**Executive Director's Recommendation**  
Commission Meeting: March 6, 2014

**Intelligence Community Campus – Bethesda (South Campus), Erskine Hall and Roberdeau Hall Renovation**

Preliminary and final approval of building plans

Figure 19: Comparison of ICC-B Master Plan vision and current massing pattern

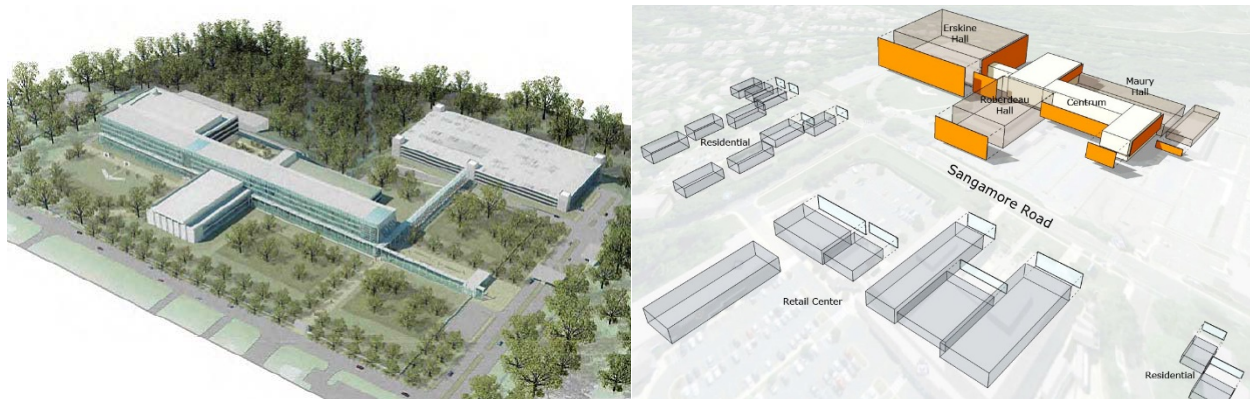
Programmatically, the Erskine Hall and Roberdeau Hall façade renovation is consistent with what is contemplated in the ICC-B Master Plan. The overall height, mass, bulk, and orientation of the current proposal are also consistent with what is contemplated in the ICC-B Master Plan, *although further refined*. The current proposal will appear less massive, and therefore less visually intrusive on the site and neighborhood, compared to what is presented in the Master Plan. Rather than creating the sense of one monolithic building mass set within a formal landscape, the current proposal maintains the massing of the existing buildings, responds to the development pattern across Sangamore Road, and allows Erskine and Roberdeau Halls to maintain their own identity as individual – historic - structures that are interconnected to other campus buildings through the Centrum. (Figure 19)
